first place

Design Review Presentation - April 6, 2011

Improved Design Incorporating Early Design Guidance Recommendations

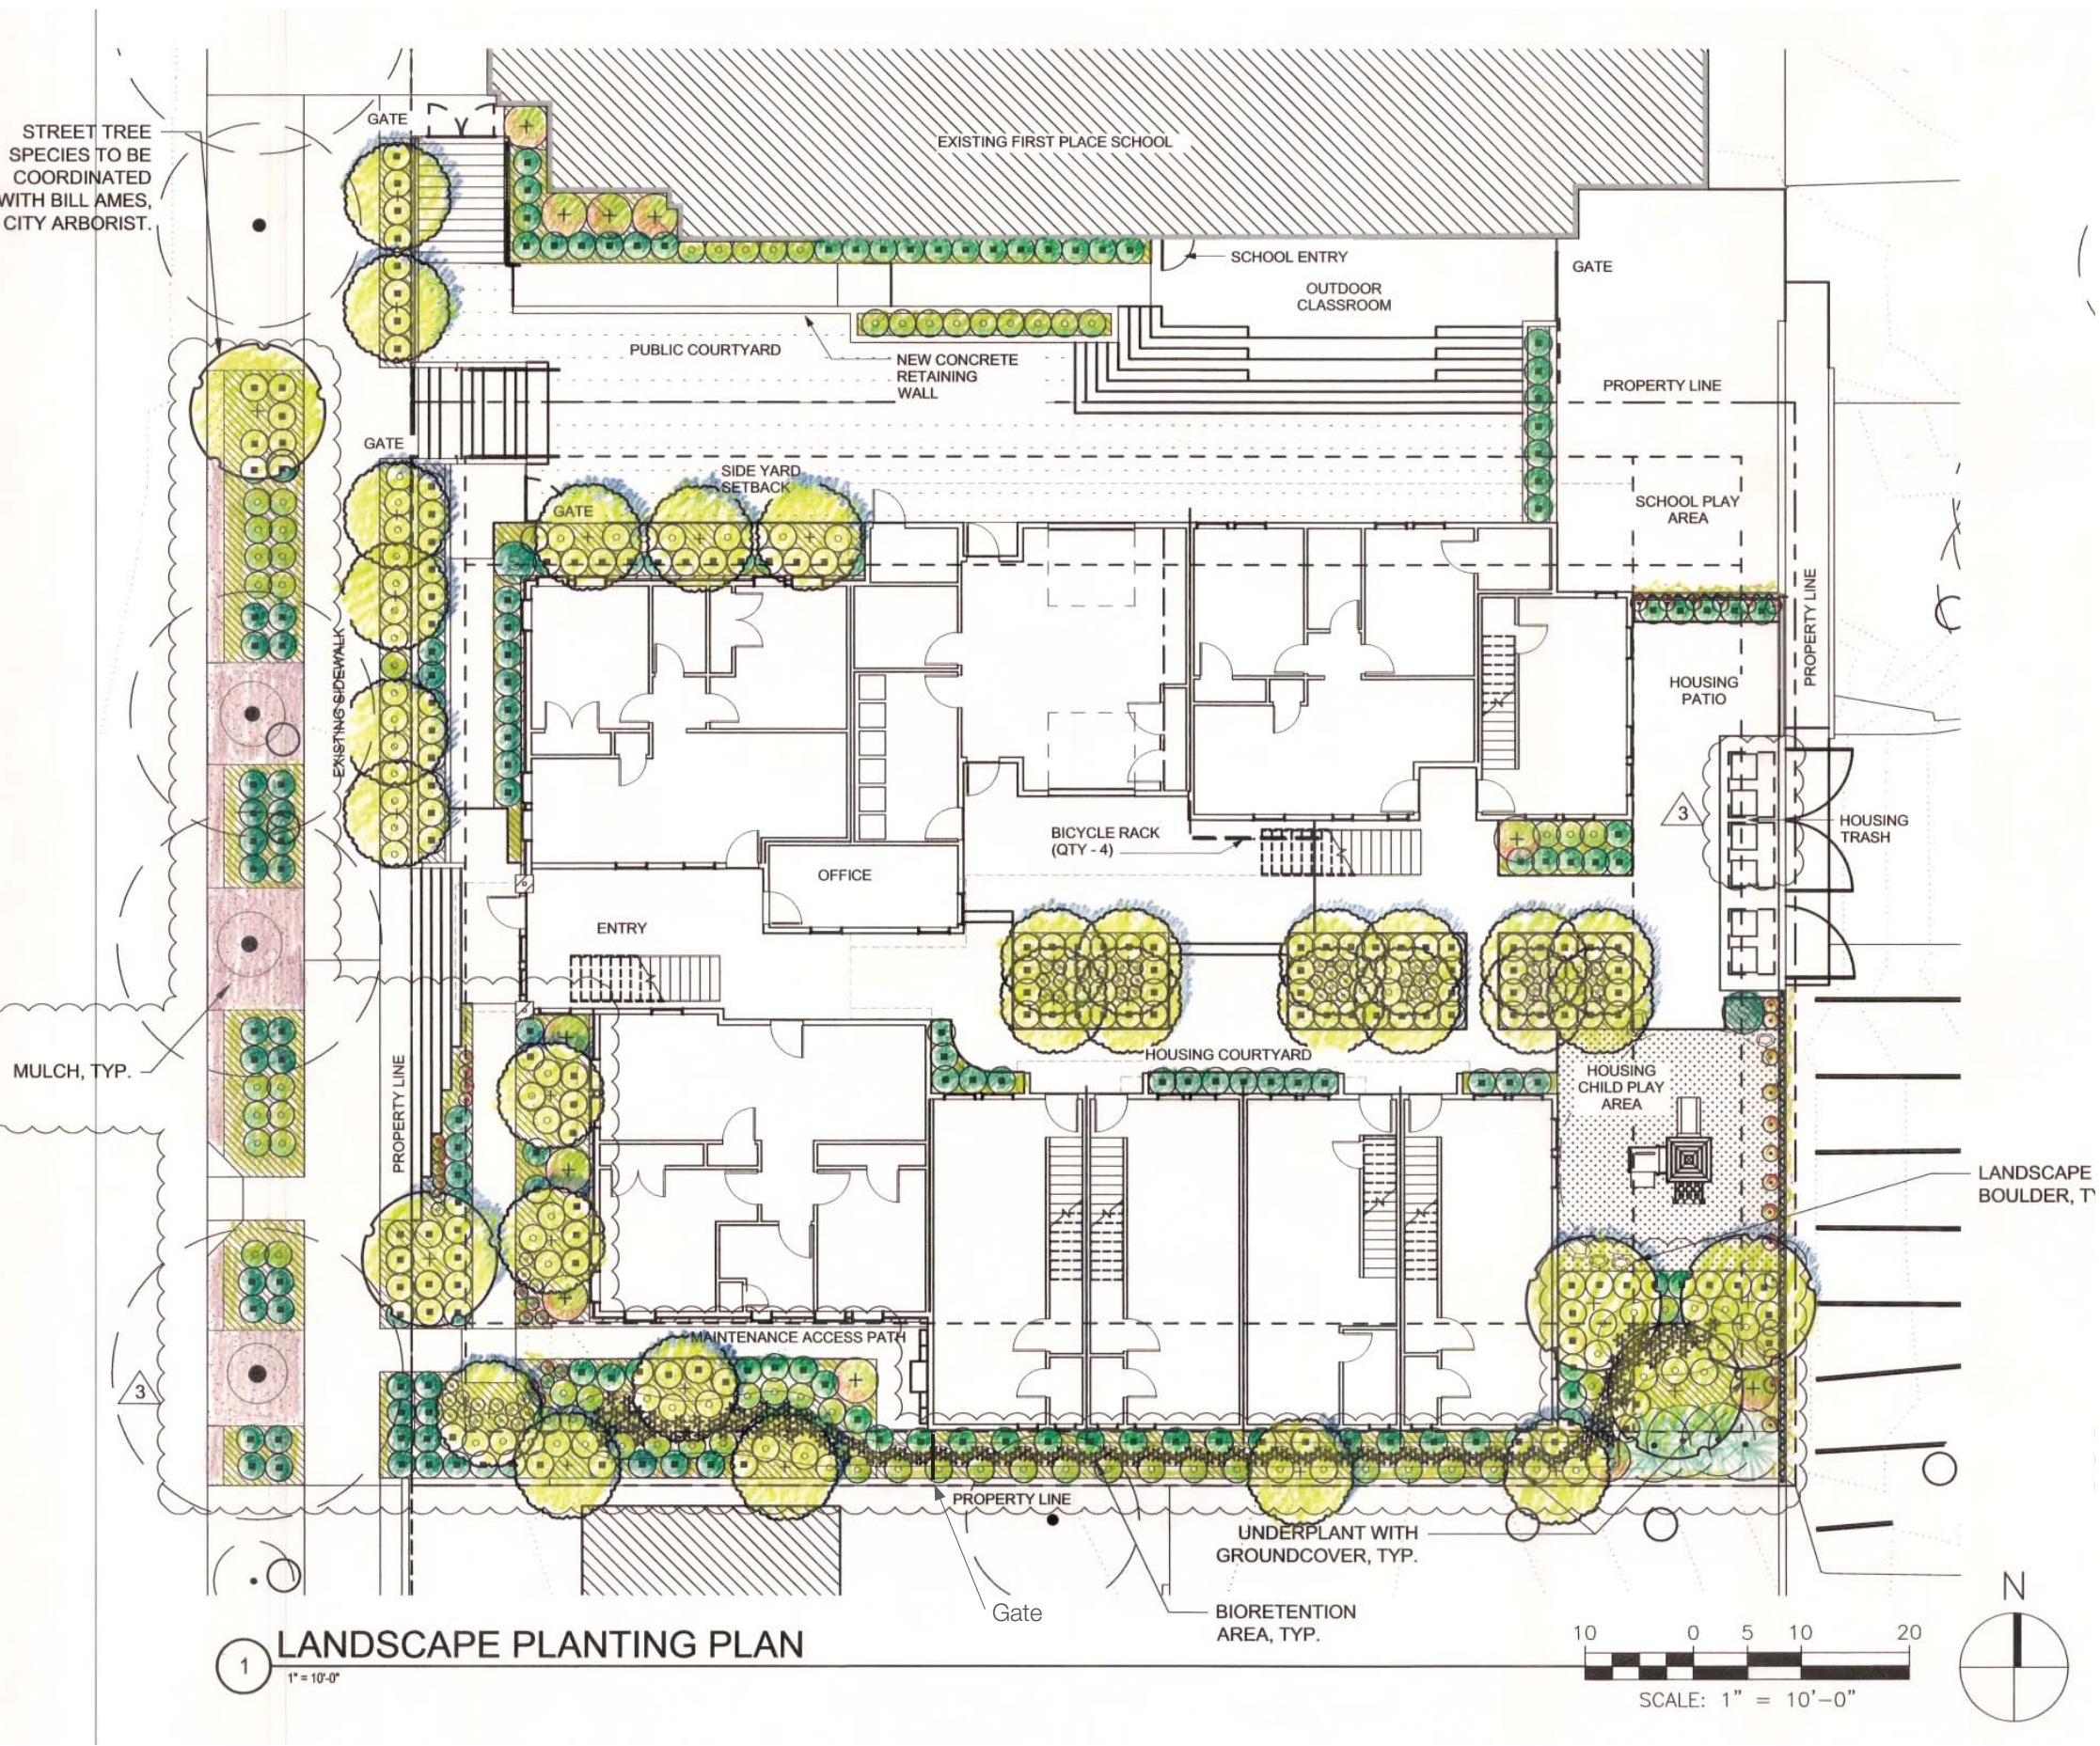
Comments reflect those in response to Guideline A-2, A-6, and A-7.

DKA response
A centralized entry now exists which is well lit from the sidewalk and located such that it is easily monitored from the office space in the inner courtyard. The entry includes a covered canopy area and an open air, but protected entry sequence that transitions residents and visitors from sidewalk to planted entry courtyard at the housing interior.

Exterior Lighting

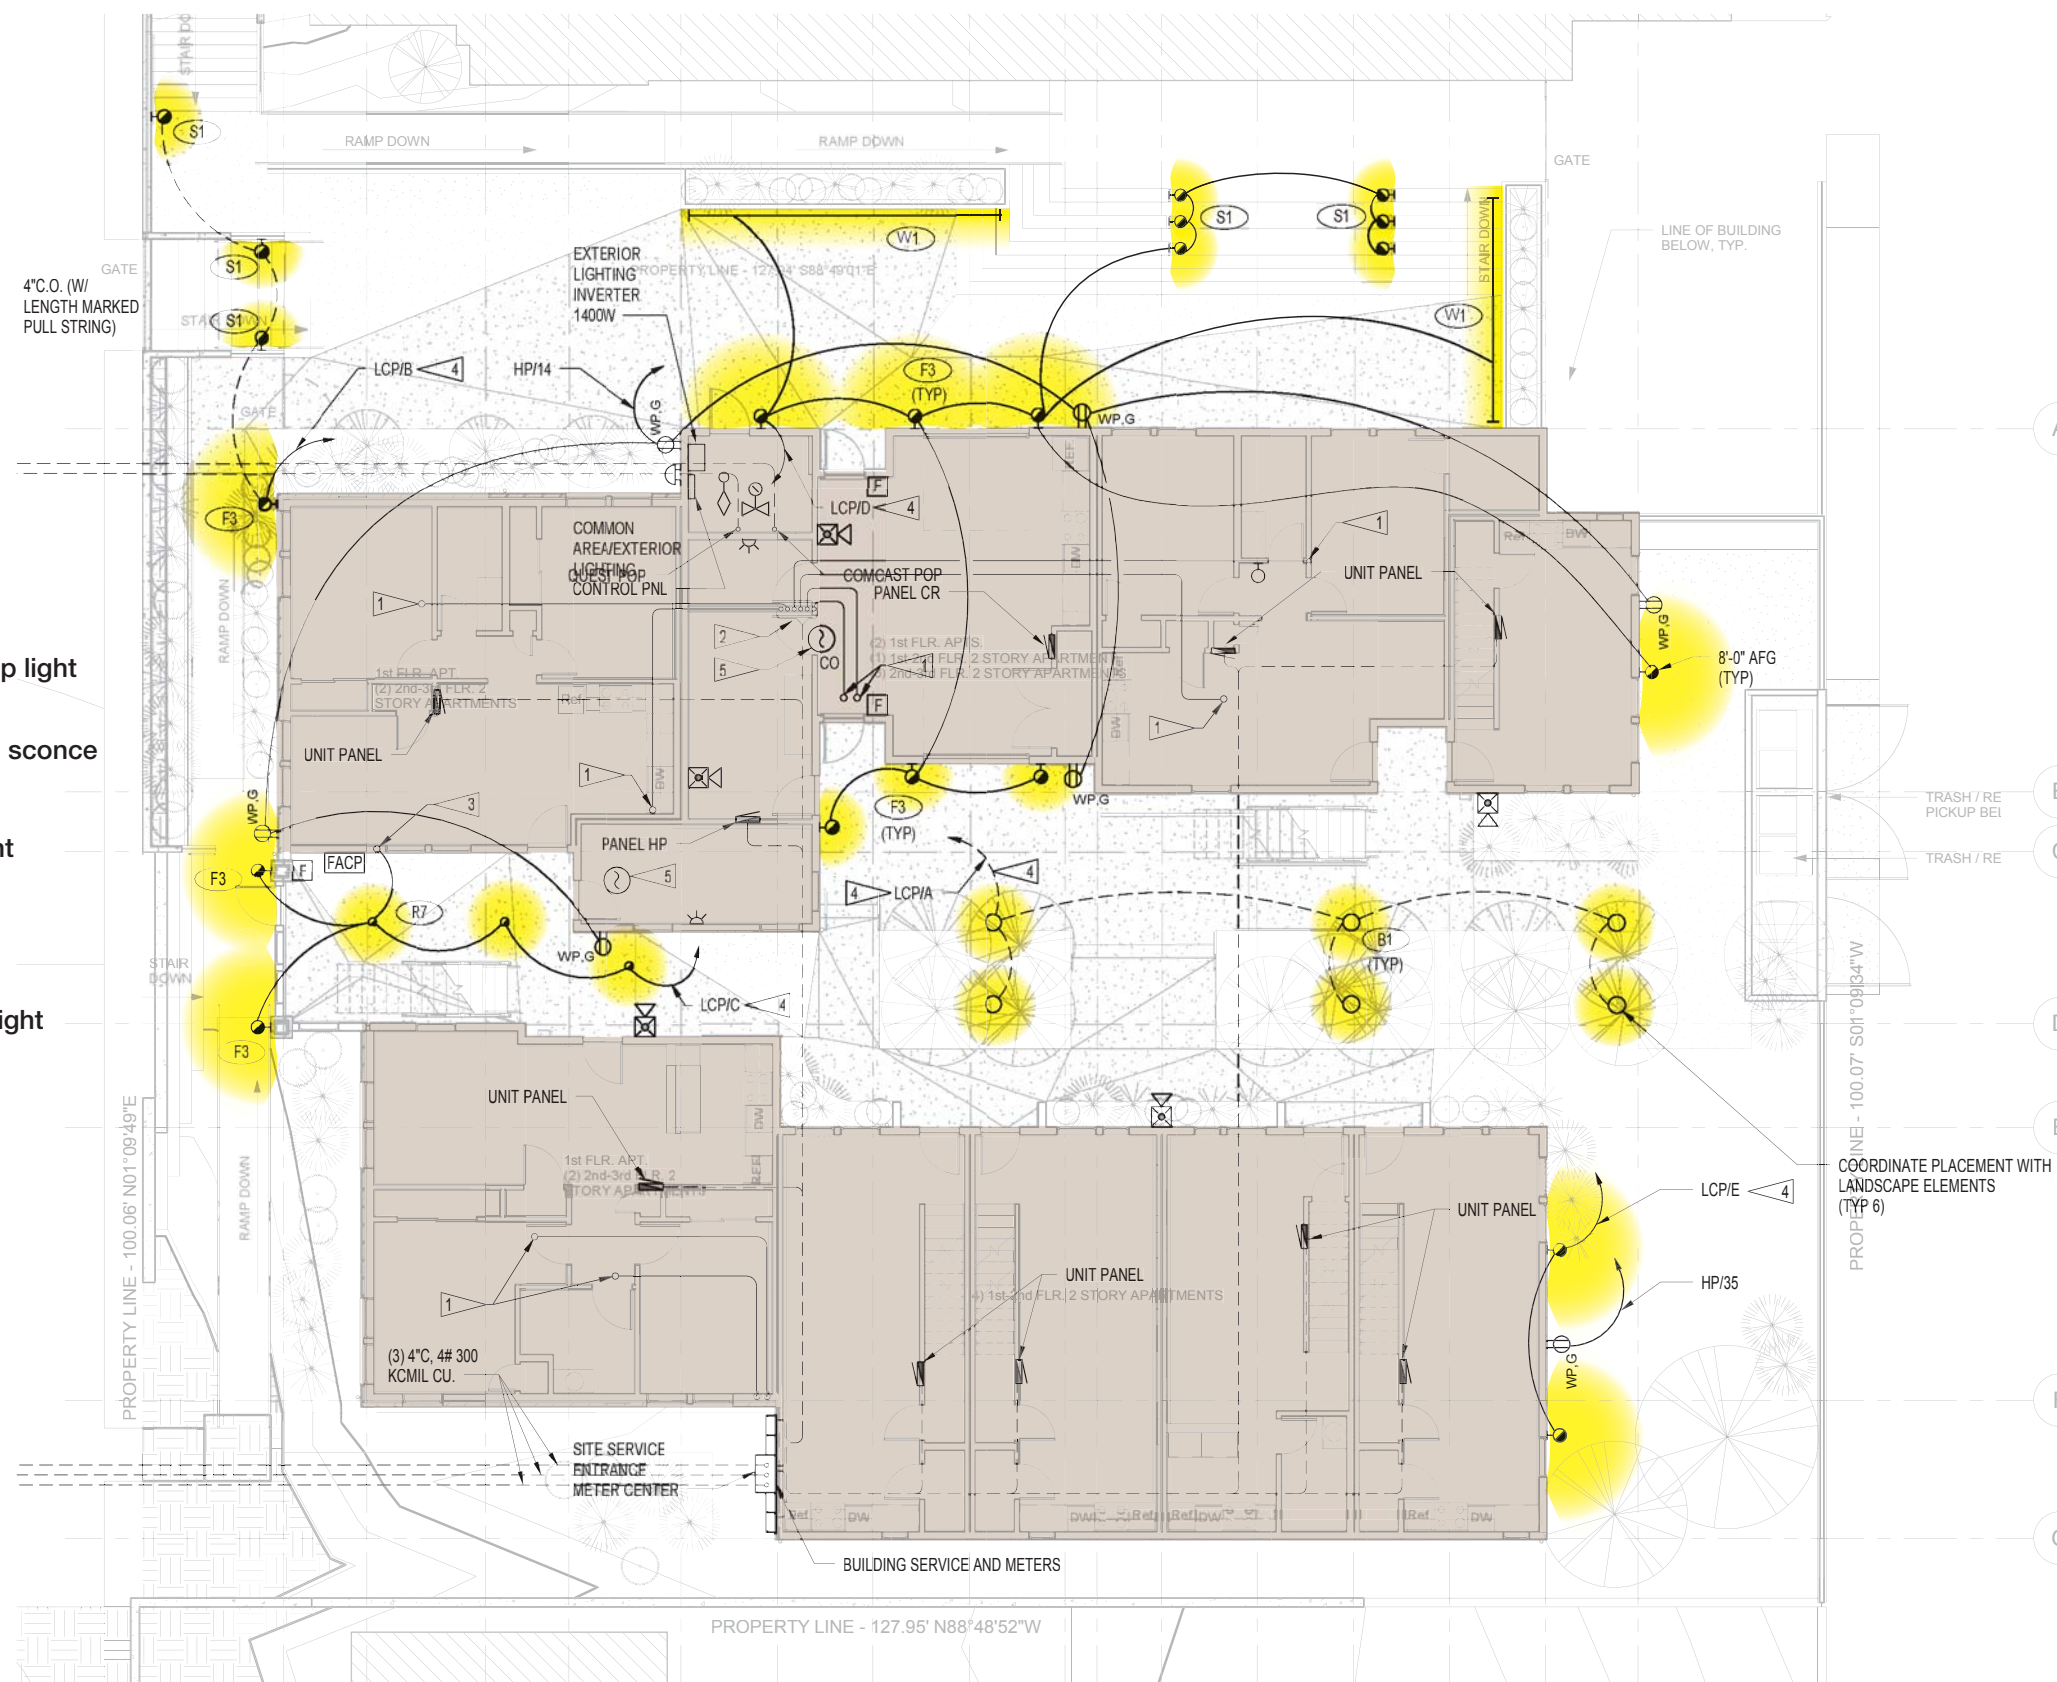
Comments reflect those in response to Guideline A-1, A-2, A-6, and A-7. The Board noted that ‘eyes on the street,’ a clearly identifiable entry, and clear sight lines will add to safety and security for residents. Multiple narrow paths and open spaces with retaining walls, blind corners, and lack of natural light will create challenges for safety and security.

All public gathering spaces and outdoor corridors have clear and obvious sight lines from units that provide the opportunity for residents to be aware of and monitor activities beyond their walls. Both office and the interior community space with large roll-up glass doors are located to provide the ability to engage and monitor adjacent outdoor spaces. Existing south-facing windows of the classrooms and offices of First Place Schools also provide monitoring of the public courtyard and outdoor classroom during the day. These spaces are secured in the evening via three gates at the west and one gate at the east end of the property. One gate along the south property line provides additional security. The secure entry, raised plinth condition along the east property line and the gate system described ensure a secure campus which is required for this client.
